South Texas Project Electric Generating Station P.O. Box 289 Wadsworth, Texas 77483

August 10, 2009
U7-C-STP-NRC-090090

South Texas Project
Units 3 and 4
Docket Nos. 52-012 and 52-013
Supplemental Response to Request for Additional Information and
Responses to Requests for Additional Information

RAI 02.05.02-19, Supplement 1

Figure 2.5S.4-79A Spatial Distribution of Low Liquefaction Factor of Safety Values, Stratum A

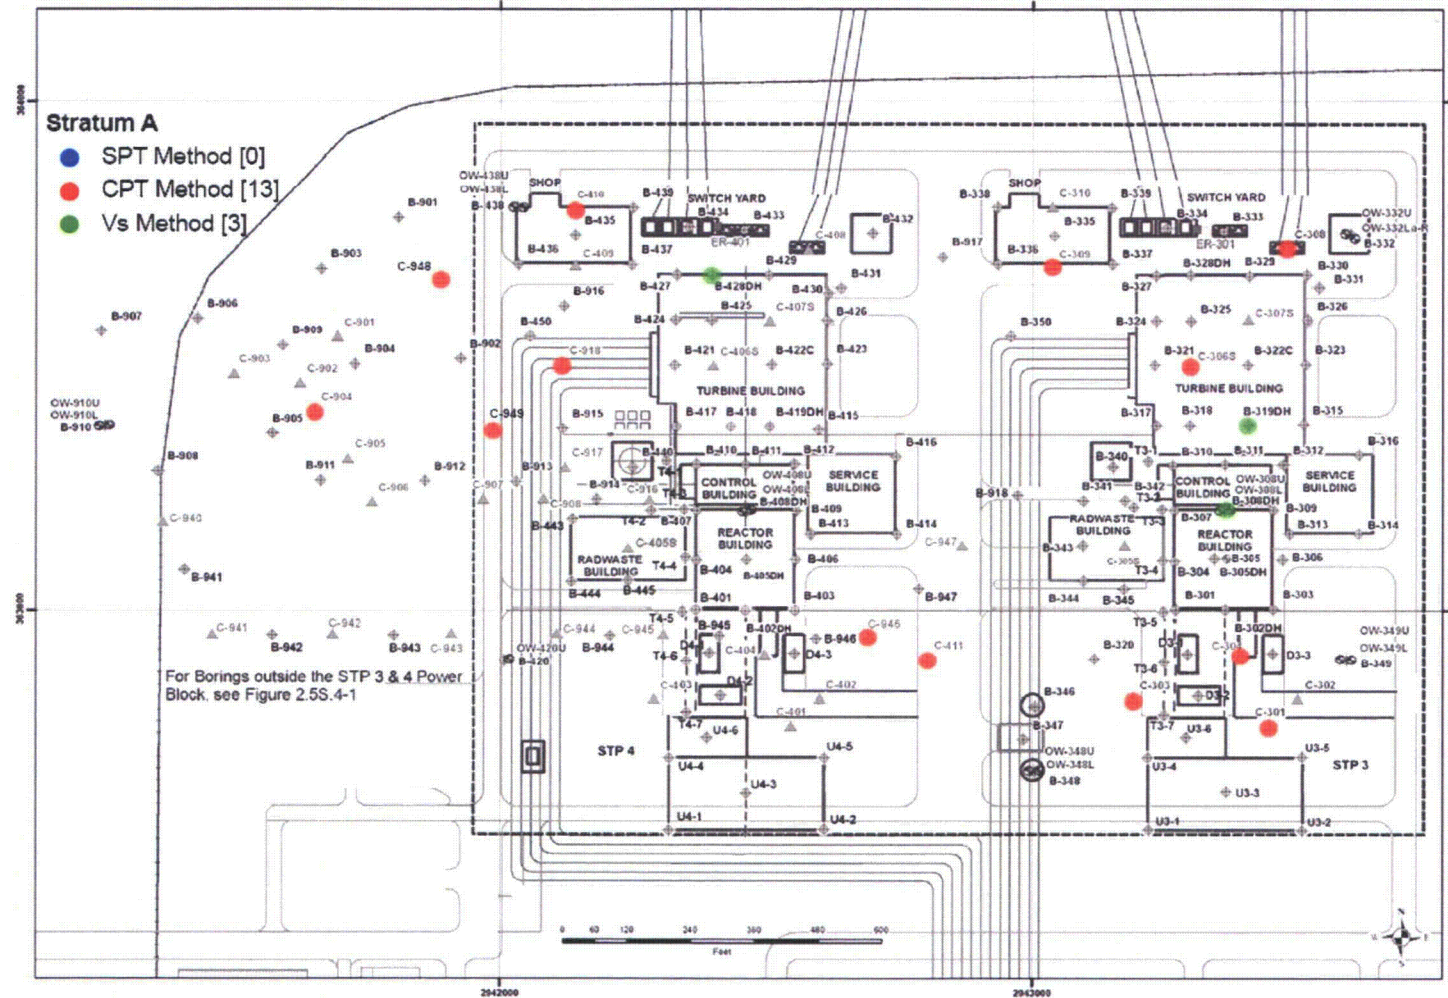
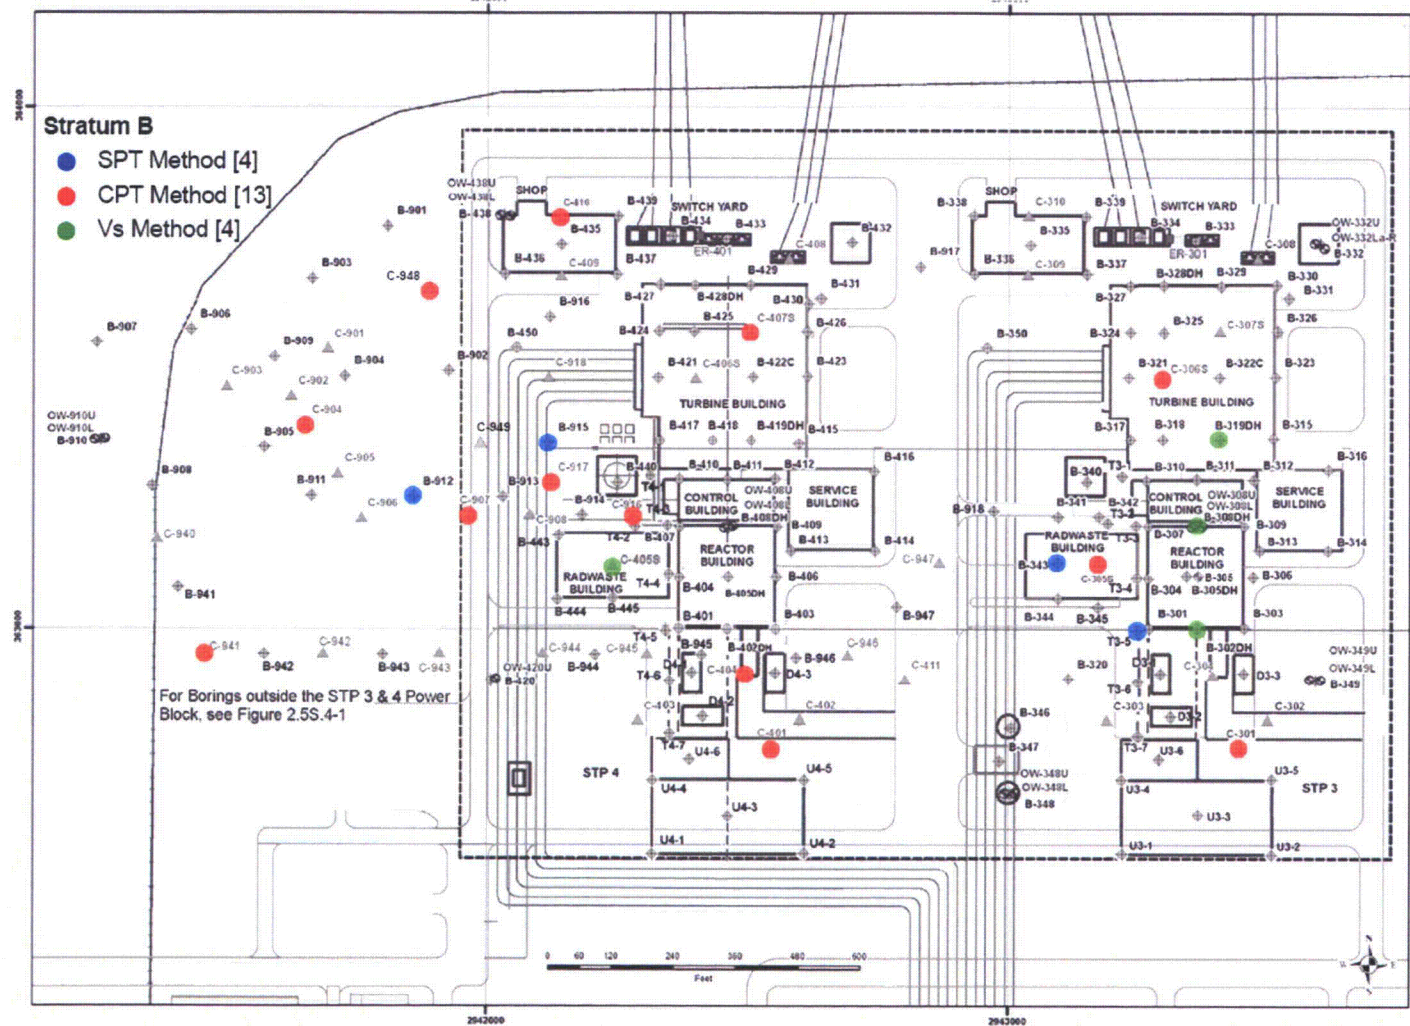
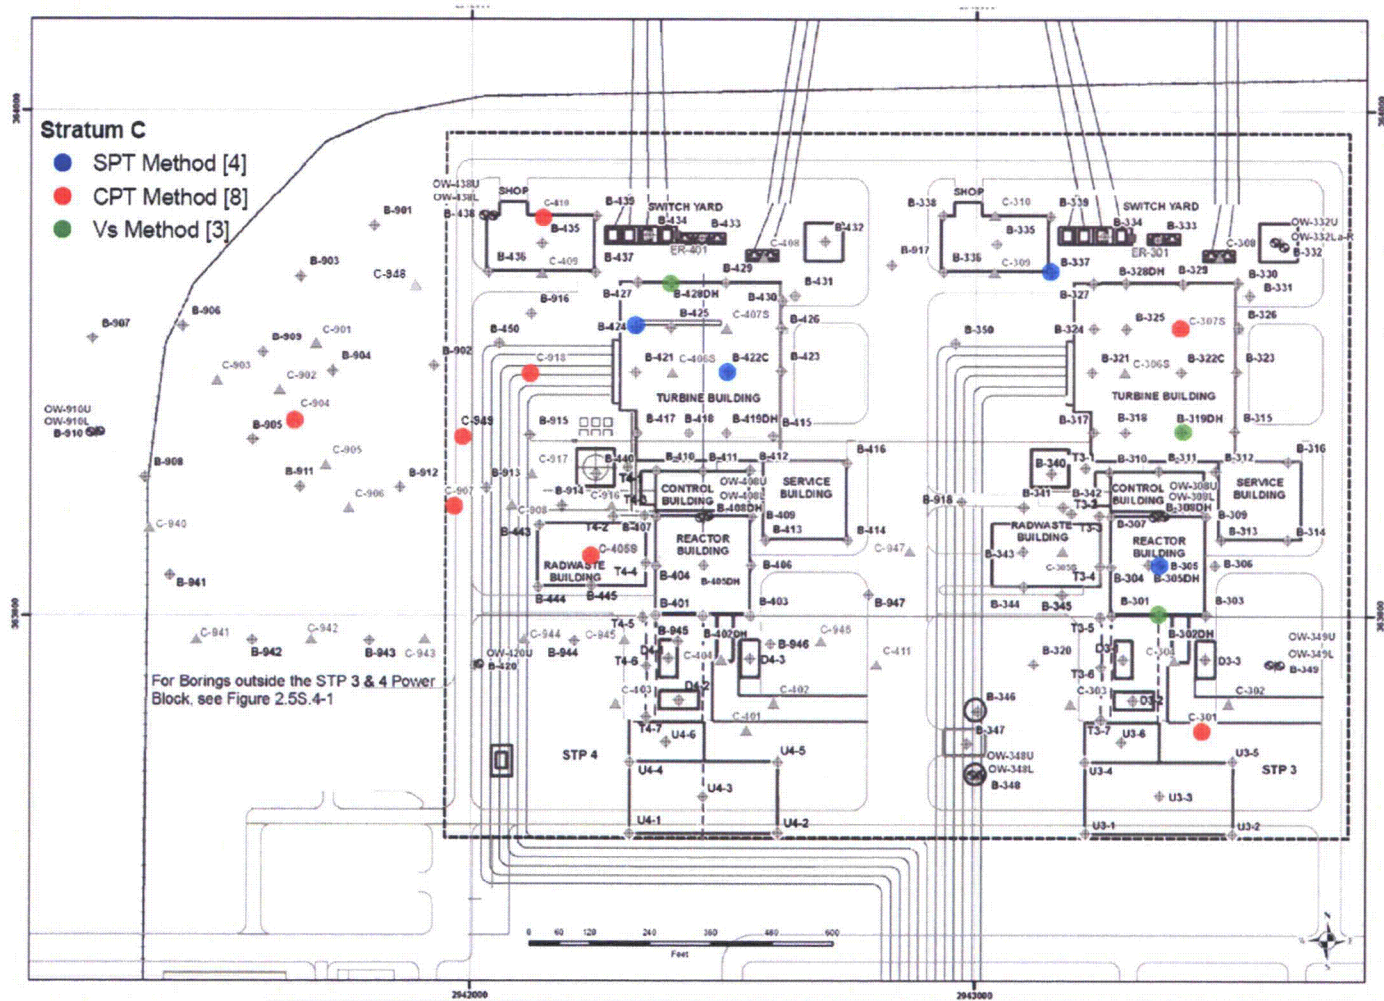
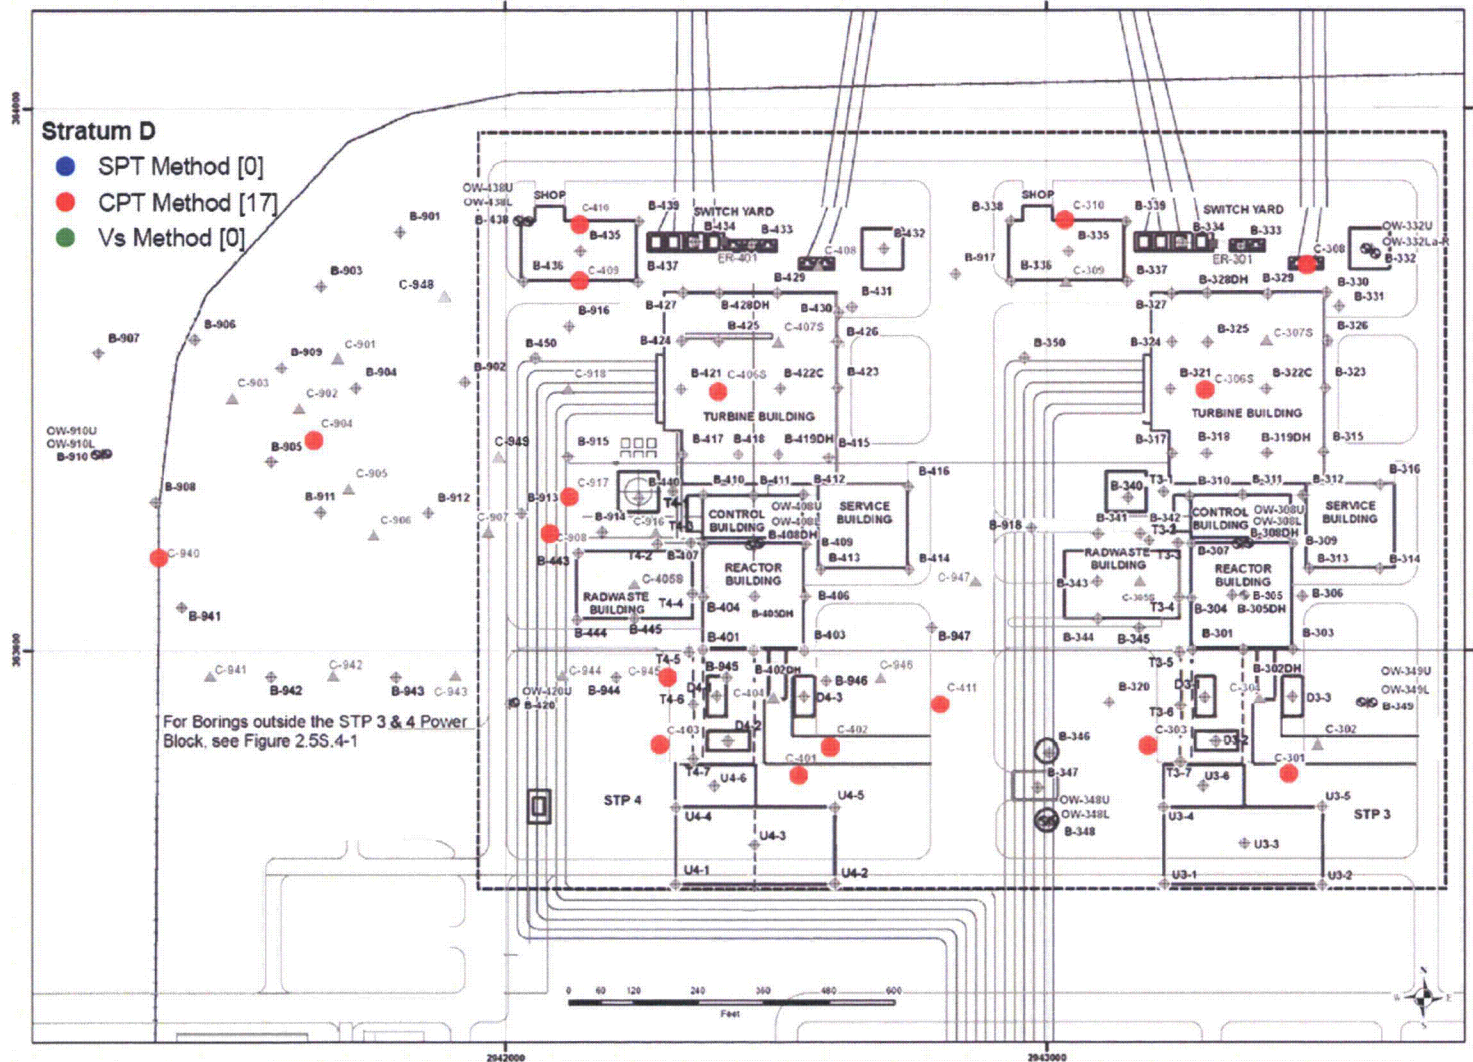
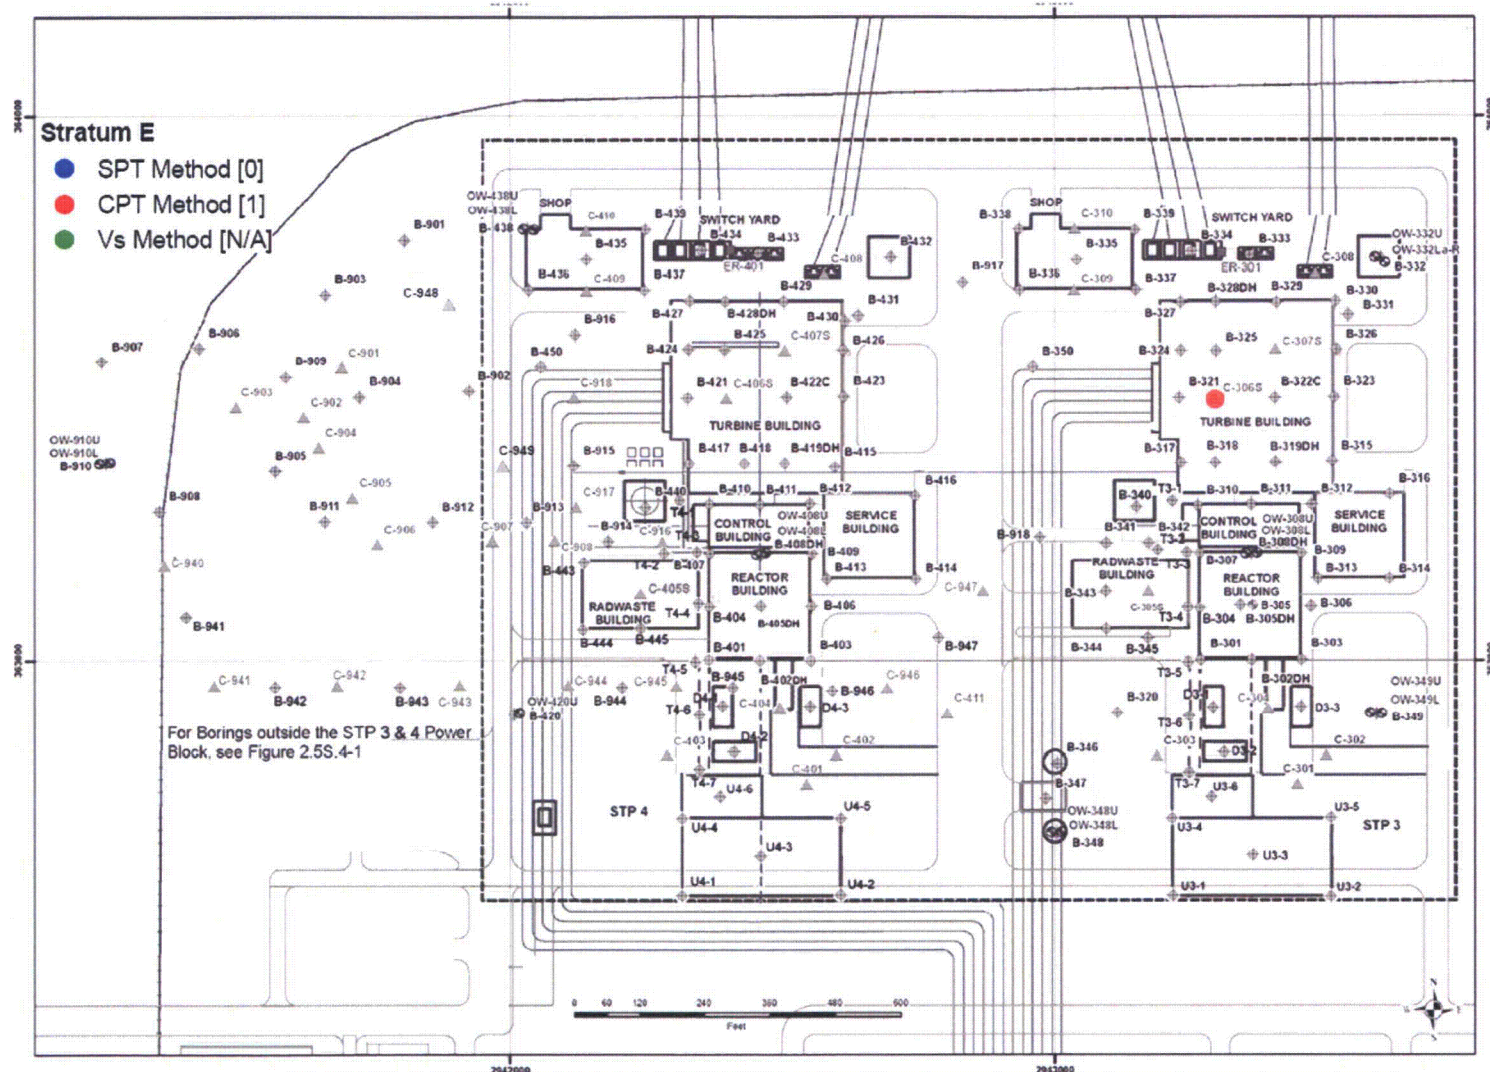
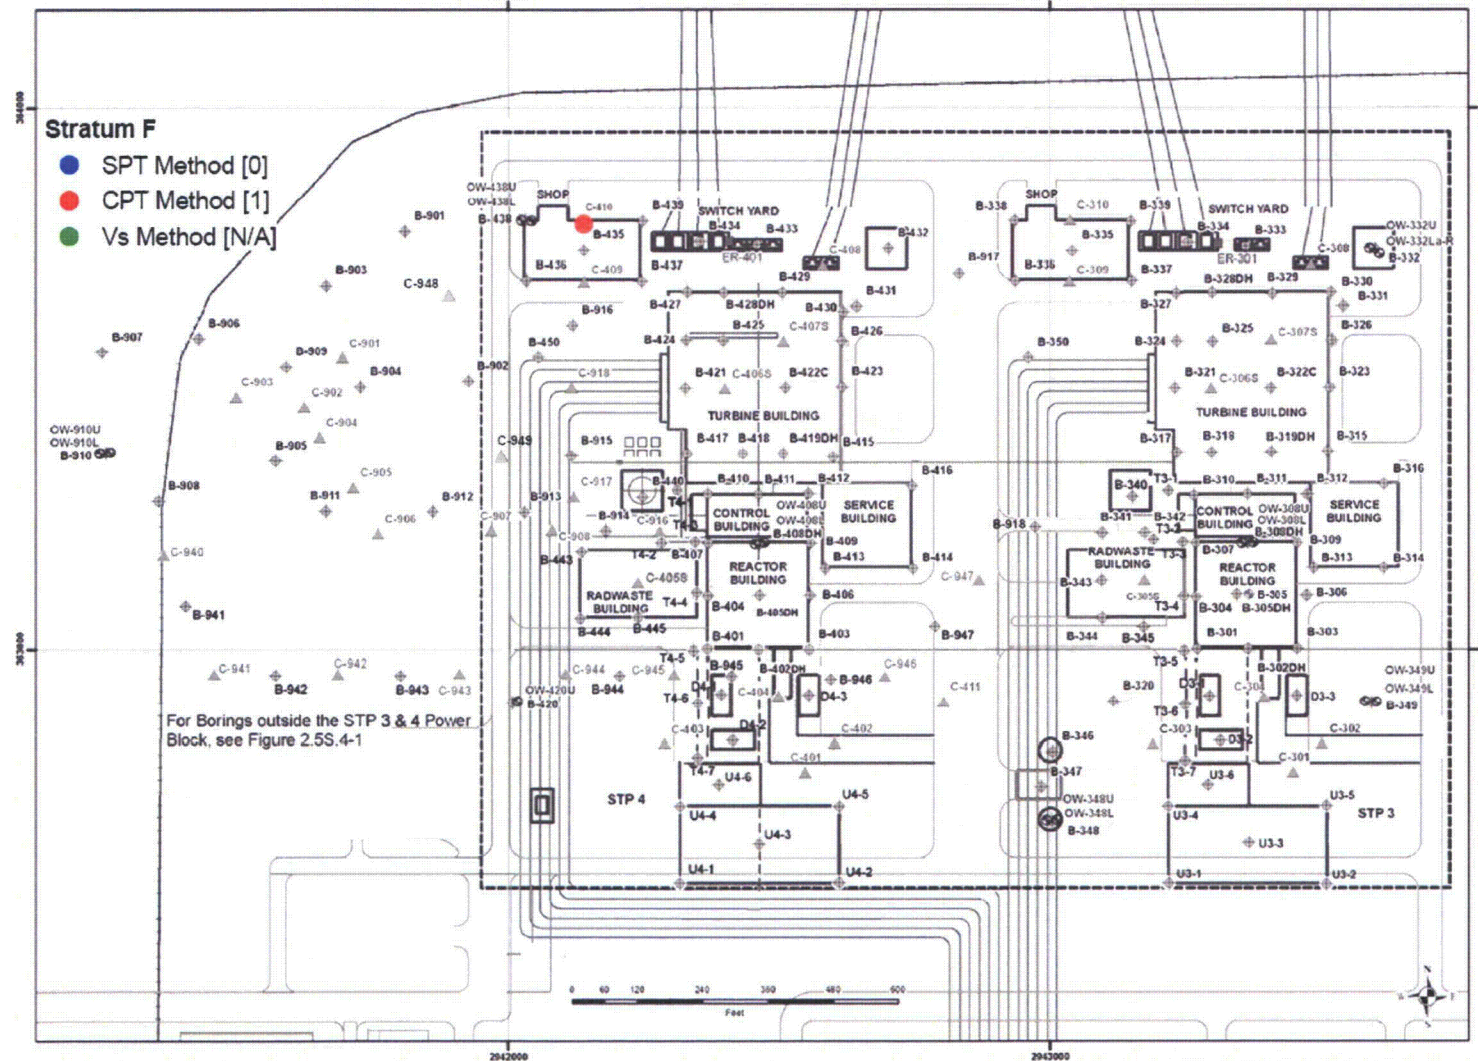
In FSAR 2.5.4.8, "Liquefaction", the results of liquefaction analyses based on STP N-values, CPT tip resistance and shear wave velocities were presented in some detail for factors of safety less than or equal to 1.1. In view of the small number of data points having factors of safety of less than 1.1 that will remain after construction, you concluded that liquefaction potential was nil. In response to RAI 2.5.4-5, you stated that graphic presentation of liquefiable zones below power block safety related structures was not possible because there are no liquefaction zones. Regulatory Guide 1.198, Section 3.2, "Factor of Safety Against Liquefaction", recommends that for factors of safety less than 1.1 and factors of safety between 1.1 and 1.4, that stability and deformation analyses should be performed with assigned strength values commensurate with the amount of pore water pressure generation. Your presentation in the FSAR does not address strength degradation for factors of safety between 1.1 and 1.4. Without a detailed explanation of those results, the liquefaction and/or strength degradation issue is not fully addressed. The staff needs the following information and data to close out this issue.

- a.) Reduction in post-earthquake strength for soils that have factors of safety (FOS) less than 1.40 is not an issue because such safety factor occurrences are not congregated as can be determined by examination of FSAR Figure 2.5S.4-79, provided as part of the FSAR markup, and supplemental Figures 39 through 49, which are also included with this response. Pore water pressure generation is assessed via estimations of post-earthquake settlement.

FSAR Figure 2.5S.4-79 depicts the spatial distribution of FOS values less than 1.10 and supplemental Figures 39 through 49 depict the spatial distribution of the FOS values between 1.10 and 1.40 for each stratum site wide for each of the three methods used to compute liquefaction potential. The plotted borings on FSAR Figure 2.5S.4-79 and supplemental Figures 39 through 49 do not illustrate a distinct pattern, congregating, or overlapping of FOS values by either CPT and V_s or SPT and V_s .

the range in elevation at which low FOS values were encountered. Figure 2.5S.4-79 identifies the soil borings and CPT locations in which FOS values < 1.10 were encountered in Stratum A through K Sand/Silt. No low FOS values were encountered in strata below Stratum K Sand/Silt. The information presented in Figure 2.5S.4-79 is discussed in this subsection.
